**Administrative Committee of the European Agreement  
Concerning the International Carriage of Dangerous  
Goods by Inland Waterways (ADN)**

#### **Draft amendments to the Regulations annexed to ADN**

At its fourth session (Geneva, 28-29 January 2010), the ADN Administrative Committee requested the secretariat to issue a consolidated list of amendments to the Regulations annexed to ADN adopted by the Safety Committee and endorsed by the Administrative Committee at its second, third and fourth sessions for entry into force on 1 January 2011 (ECE/ADN/8, para. 19).

**"Figure 2.4.3.1: Categories for substances long-term hazardous to the aquatic environment**

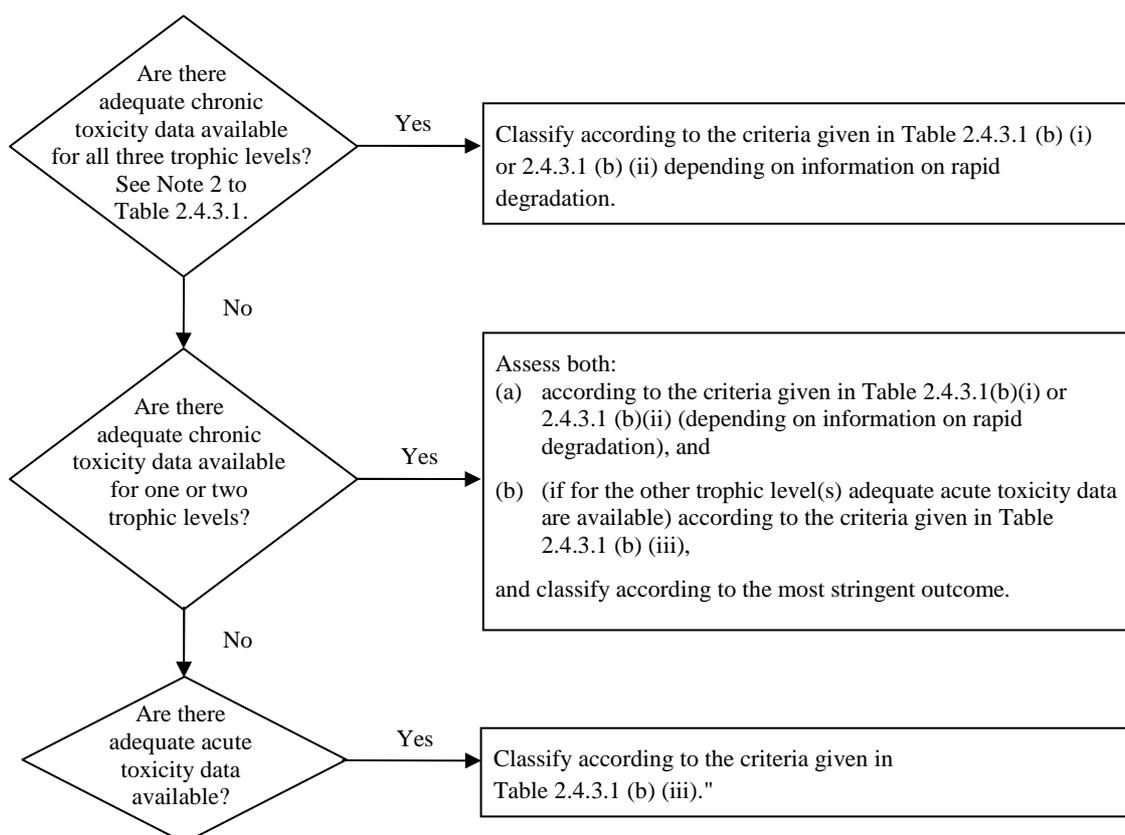
2.4.3.1 Add the following figure:

Excepted quantities mark  
Hatching and symbol of the same colour, black or red,  
on white or suitable contrasting background

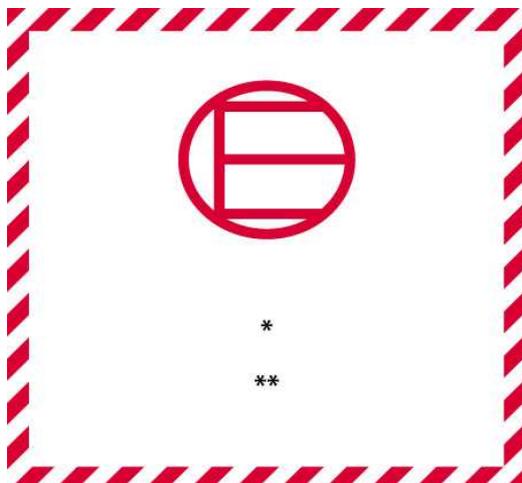
3.5.4.2 Amend the figure to read as follows:
